SECTION 2 Block 02_Roof Plan

FOR FULL SUMMARY OF PROPOSED CHANGES SEE SECTION 1.

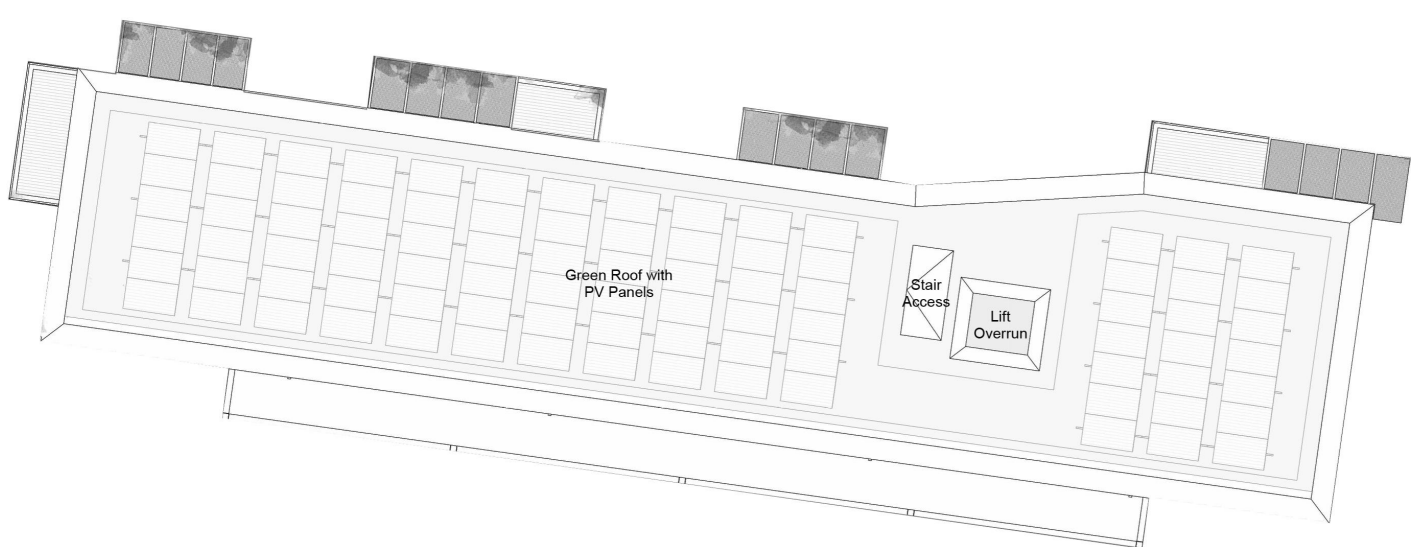
- 3. Corner bolt-on balconies cantilevered reduction.
- 13. Roof AOVs on top of stair core and lift lobby added.
